**EAST GOSHEN TOWNSHIP
PLANNING COMMISSION
Meeting Agenda
Wednesday, March 6, 2019
7:00 PM**

Date: 3/1/2019
To: Planning Commission
From: Mark Gordon, Township Zoning Officer 
Re: Land Development Application / ESKE Development LLC / Ducklings Early Learning Center

**RE: ESKE Development, LLC, 1302 Wilson Drive
Preliminary/Final Land Development Review**

Re: Preliminary/Final Land Development - Ducklings Early Learning Center
East Goshen Township – LD-01-19-15745

SEWER LATERAL/BUILDING SEWER DETAIL
NOT TO SCALE

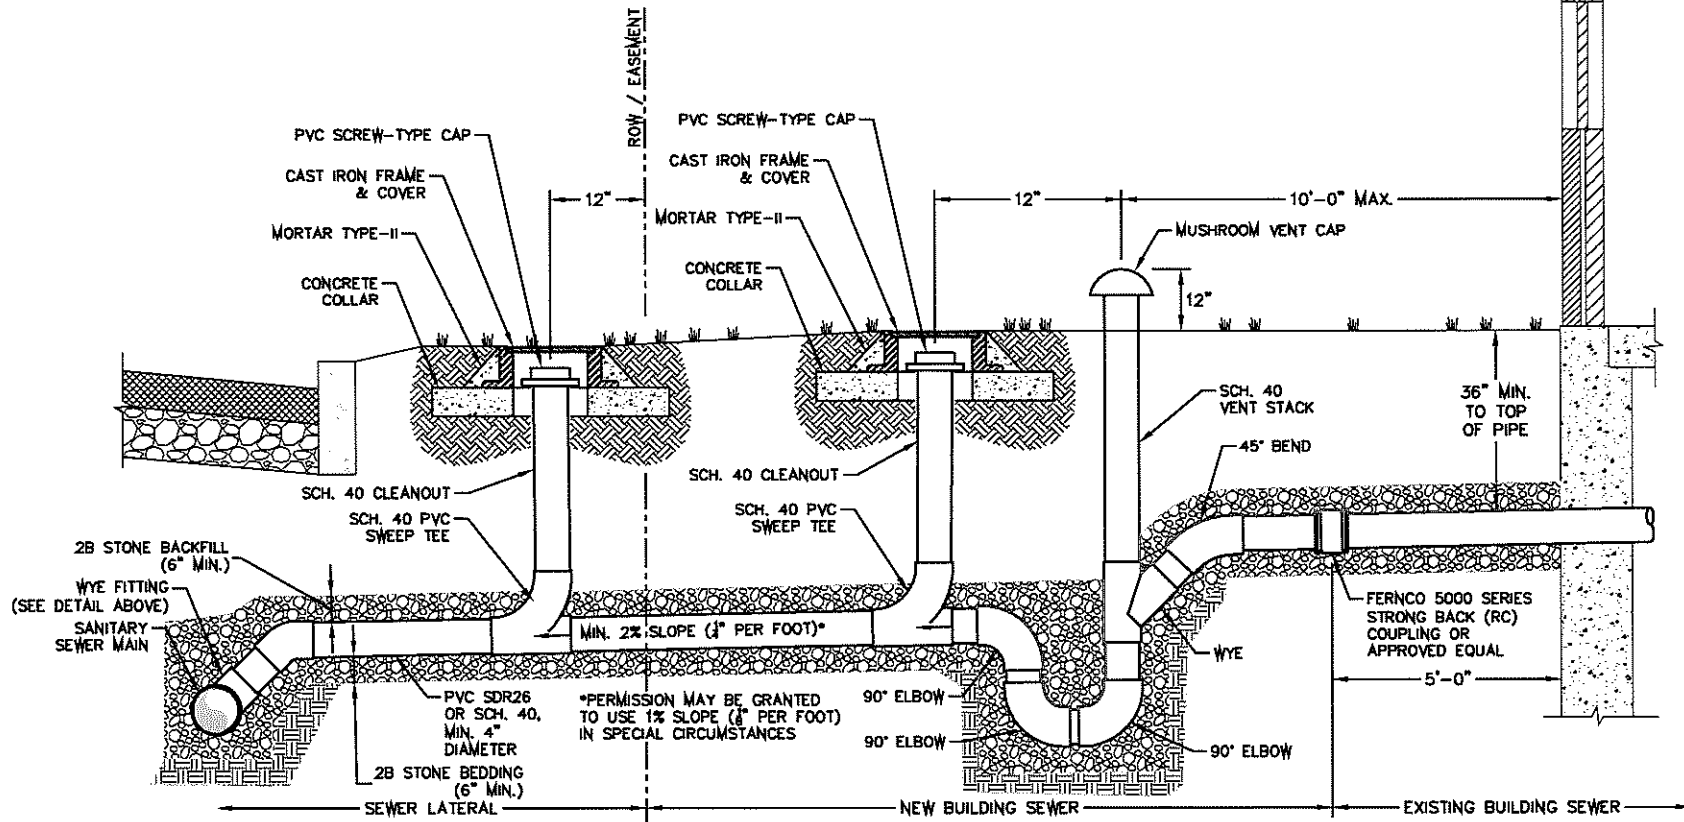
33. We recommend the building sewer and lateral be increased in size from 4-inch to 6-inch since this is a commercial use and to increase ease of maintenance. (§188-31.B.(3))
34. Township policy prohibits inside drop connections within manholes. To avoid disturbance to the manhole at all, we recommend the lateral connect directly to the sanitary sewer main approximately 5 feet downstream of the existing manhole in accordance with the Township's *Sewer Lateral/Building Sewer Detail* (see attached). The lateral can connect to the main at a 45° angle and run at that slope to the easement line. The downstream cleanout needs to be provided at the easement line. The sewer can then be run at a consistent slope from the cleanout to the building.

35. A trap, vent, and building cleanout are required in accordance with the Township's *Sewer Lateral/Building Sewer Detail*.
36. The elevation view on Sheet 3 of the retaining wall plans, prepared by Shippee Engineering, dated February 1, 2019, indicate the invert elevation of the sewer lateral at the location of the retaining wall as 426.94, which is not consistent with the calculated invert elevation of 428.98, based on the length, design slope, and invert elevations indicated on Sheet 3 of the land development plans.

Site Plan Detail, Sheet 1: Preliminary/Final Land Development - Ducklings Early Learning Center

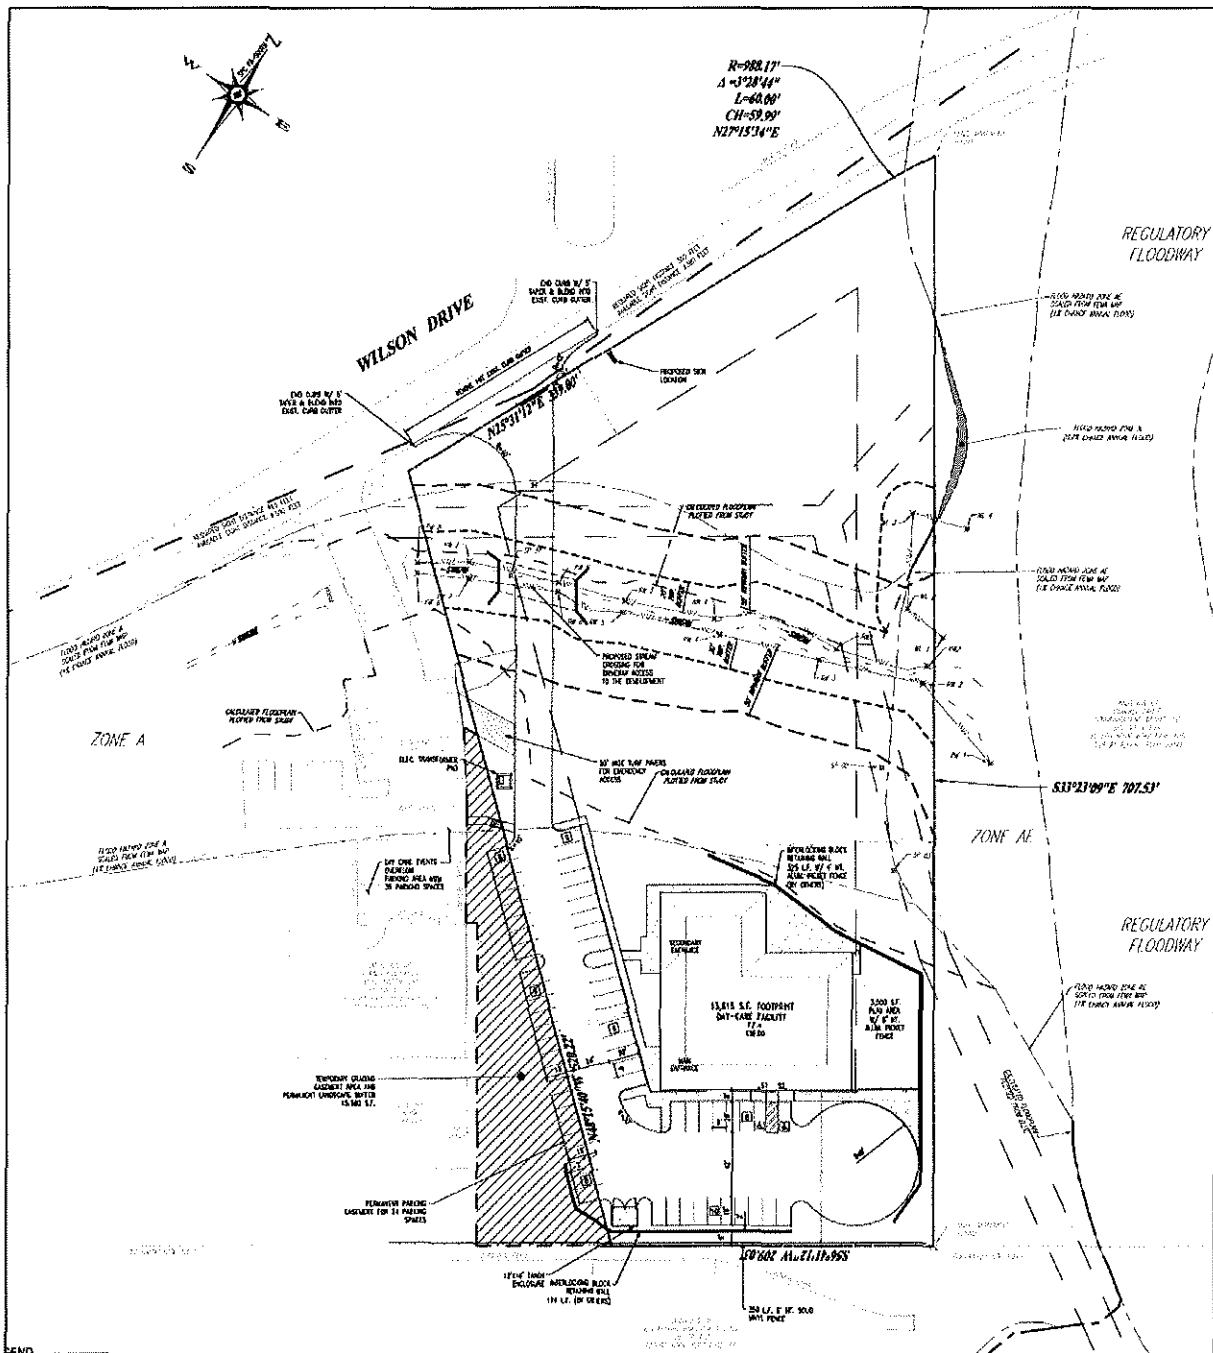
3. While the site plan depicts a stream crossing for the proposed driveway entrance, the details of which are provided on Sheet 8, we note that this stream crossing is located approximately 110 feet east of an existing stream crossing on the adjoining parcel to the west (UPI# 53-3-1.2D). We suggest that the applicant and Township investigate the feasibility of utilizing the main driveway entrance on the

4. The site plan indicates that an emergency access connection will be provided to the adjoining parcel to the west. However, the site plan indicates that the emergency access connection extends to an existing parking area, and it does not depict any modifications to the existing parking arrangement (any cars utilizing these parking spaces would block this emergency access connection). This should be clarified by the applicant. We also suggest that the applicant and Township investigate the feasibility of an emergency access connection with the adjoining parcel to the south.

6. The Zoning Information table on Sheet 1 indicates that the applicant is proposing 21 more parking spaces than required by the Township Zoning Ordinance (this figure does not include the 35 spaces identified on the adjoining parcel to the west as a "day care events" overflow parking area). We suggest that the applicant and the Township evaluate the actual anticipated parking demand for this facility, and determine whether the number of proposed parking spaces will be necessary. If fewer spaces are required, we suggest that the extra spaces could be landscaped and held in reserve instead of being paved. The reserve spaces could be installed in the future if it becomes evident that they are actually needed. Reserving parking spaces in this manner can help to reduce initial construction costs, limit the creation of impervious surfaces, and increase opportunities for landscaping.

7. The site plan depicts the location of a sidewalk connection extending to the overflow parking area on the adjoining parcel to the west. However, this sidewalk extends to an existing parking area, and the site plan does not depict any modifications to the existing parking configuration in order to facilitate pedestrian access between these parcels. This should be clarified by the applicant.
8. The Township should verify that the design of the proposed outdoor lighting plan (Sheet 13) conforms to Township ordinance requirements. The illumination should be directed inward from the periphery of the site and be oriented to reduce glare and visual impact on the adjoining roadways and land uses.

13. The Zoning Information table on Sheet 1 indicates that conditional use approval is required for this project. The final plan should accurately note the date and any conditions set as part of the conditional use approval, and the Township should verify that all applicable conditions of approval have been incorporated into the final plan.
